Arlington Zoning Board of Appeals

4. **Thorndike Place: Discussion of Architectural and Urban Design Aspects of Project Submission.**
5. **Thorndike Place - Updated Documents from Applicant**
6. **Thorndike Place - Public Comments**
7. **Thorndike Place - Previous Correspondence Received**
8. **Thorndike Place - New Documents**

Type	File Name	Description
▢ Reference Material	2021-01-18_Stormwater_Report.pdf	2021-01-18 Stormwater Report
▢ Reference Material	2021-01-22_Response_to_Stormwater_Peer_Review-Thorndike_Place.pdf	2021-01-22 Response to Stormwater Peer Review-Thorndike Place
▢ Reference Material	FIA_Thorndike_Place_(00186746xBC4F6).pdf	FIA_Thorndike Place (00186746xBC4F6)
▢ Reference Material	2021-01-21_Revised_Plan_Sheets.pdf	2021-01-21 Revised Plan Sheets
▢ Reference Material	2021-01-25_Response_to_BETA_Traffic-Thorndike_Place_with_Attachment.pdf	2021-01-25 Response to BETA Traffic-Thorndike Place with Attachment
▢ Reference Material	Thorndike_Place_Revised_Wetland_Delineation_Memo_2021-01-18_with_Field_Data_Forms.pdf	Thorndike Place Revised Wetland Delineation Memo_2021-01-18 with Field Data Forms

Figure 6R
2027 No-Build
Weekday Evening
Peak Hour Traffic Volumes

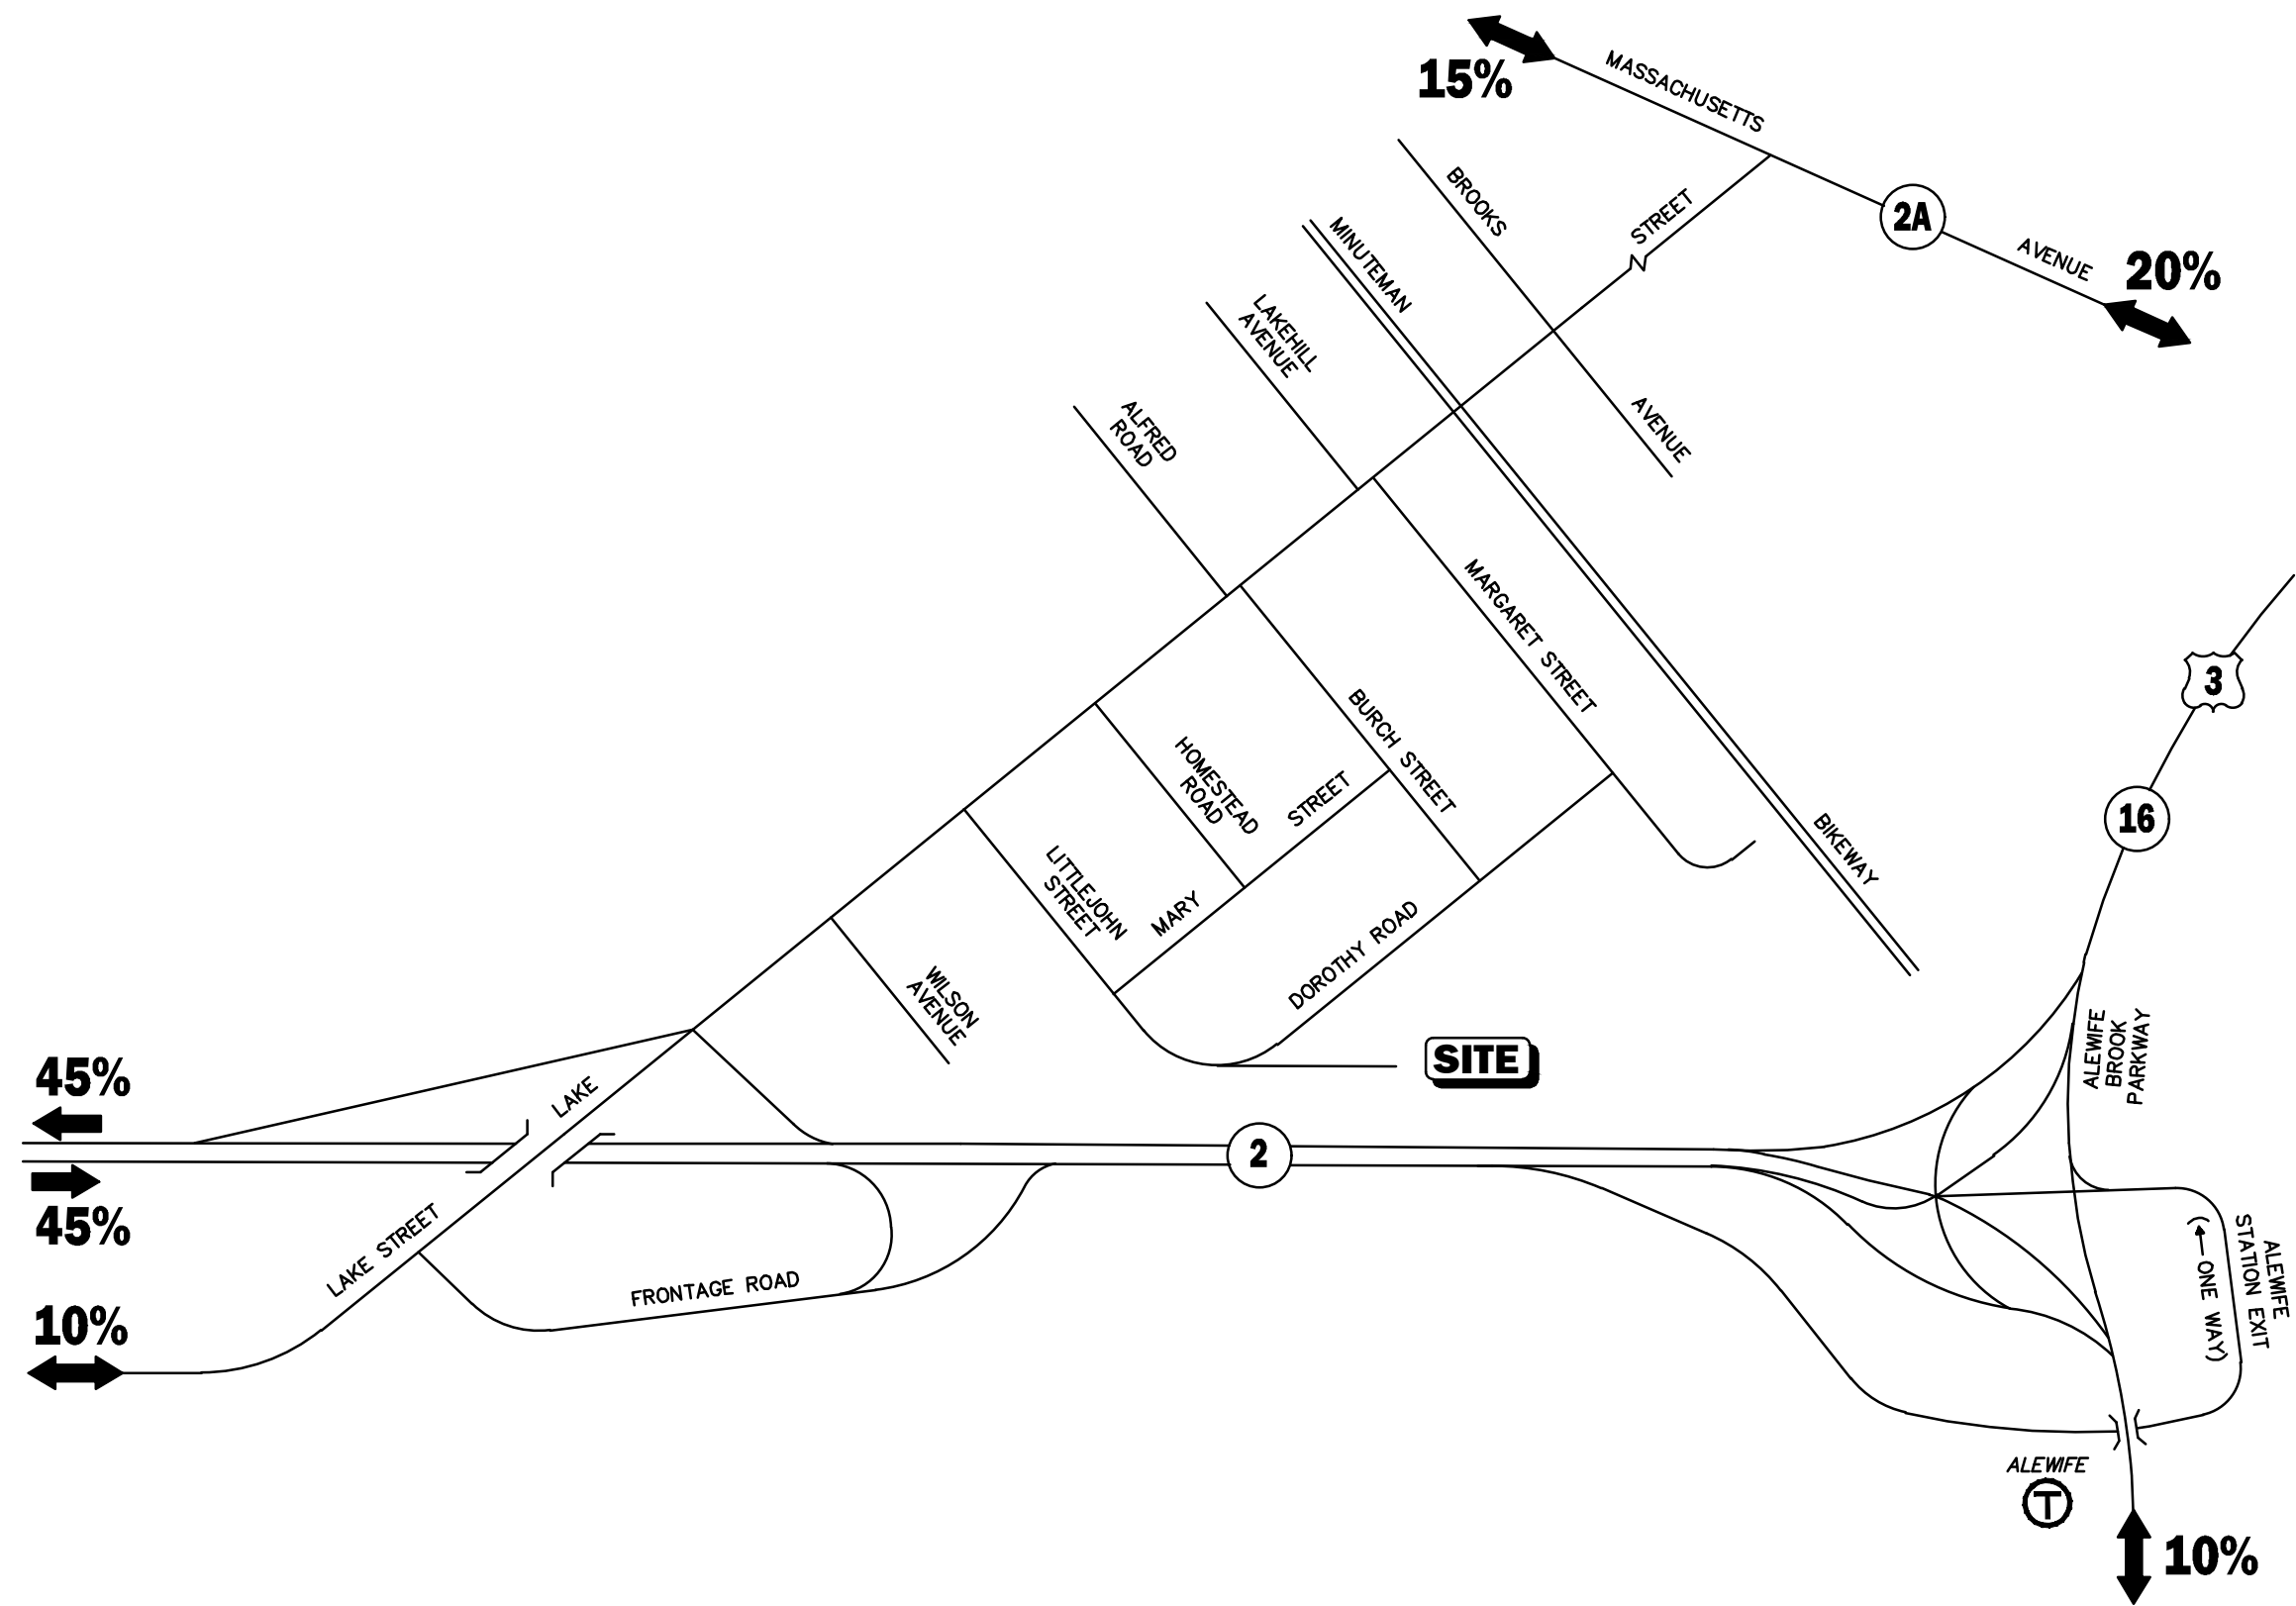
Comment No. 39: *“Lake Street through volumes at the Minuteman Bikeway presented in the 2027 No-Build evening analysis were found to be lower than those presented on Figure 6 of the TIA. Update accordingly.”*

Response: Table 12R above shows the revised level-of-service results of the analysis. The through volumes at the Minuteman Commuter Bikeway presented in the 2027 No-Build evening analysis have been updated to match the volumes on Figure 6R.
